Planning & Infrastructure Department
Heritage + Urban Design (HUD)

MEMO TO: Leigh Ann Penner, Senior Planner
FROM: Kunal Chaudhry, Senior Urban Designer

SUBJECT: OFFICIAL PLAN AMENDMENT, ZONING BY-LAW AMENDMENT

Applicant Name: Smart Centres / South Hill
Municipal Address: 9301, 9325 and 9335 YONGE STREET
City File No.: D01-20015 and D02-20029

Fig. 1.0 Consider an additional residential use bay to line the above grade structured parking on the West Elevation

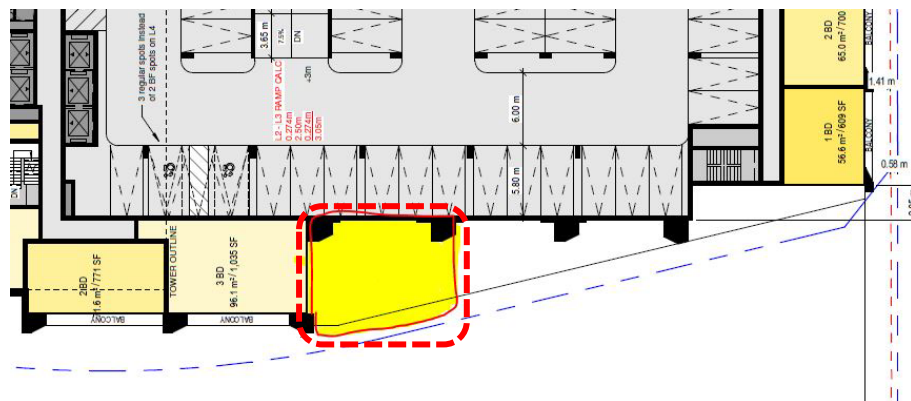
2. Liner Residential Uses for the West Elevation	While secondary to the North elevation, the West elevation is a prominent façade since it faces a future subway station. Staff note and appreciate the efforts made to mitigate the visual impact of the above grade-structured parking through a recess from the primary face of the built form. However, we strongly recommend the applicant consider additional residential units to line another bay of the parking structure. This will ensure that a smaller percentage of the structured parking face will be exposed on a prominent elevation. Please refer to the images below (Fig.1.0-3.0) for further clarification. We find that an opportunity exists to add fairly sized units to this portion of the floor plans	UDG 5.4.28-31
--	--	---------------

Fig. 2.0 A liner residential used for the highlighted portion will visually mask a greater percentage of the structured parking on the West elevation.

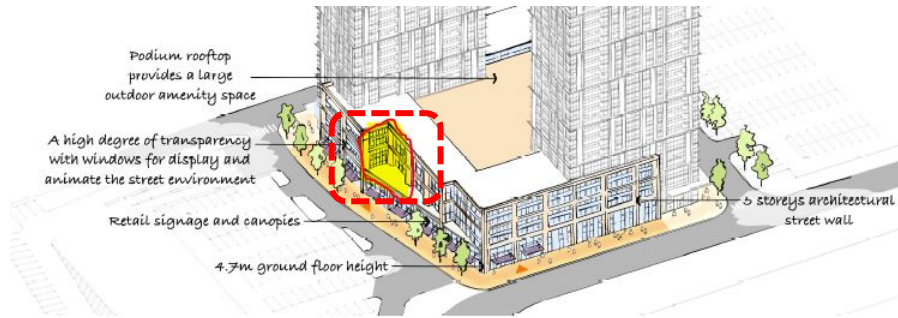
Fig. 3.0 The addition of a residential bay within the podium as a liner use for the structured parking will be in line with the general design vision for above-grade parking facilities in the City.

Fig. 5.0 Consider an active green roof with tall planting along the edge of the North face, atop the base building, to up visual interest along the east-west Market Promenade

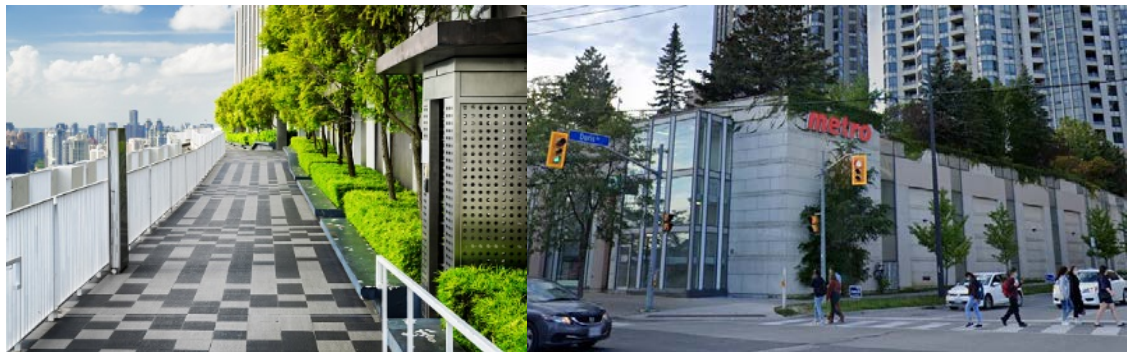
9. Rooftop Amenity/Green Rooves	<p>In light of the Market Promenade concept, the applicant is encouraged to consider a green roof or rooftop amenity space that extends to the Northern face of the base building.</p> <p>Consider rooftop planting that will be visible from the streetscape to further the notion of a specialized street, not just for the subject lands or the KDA, but the city as a whole.</p>	UDG 3.3 UDG 6.5.29 UDG 6.8.16
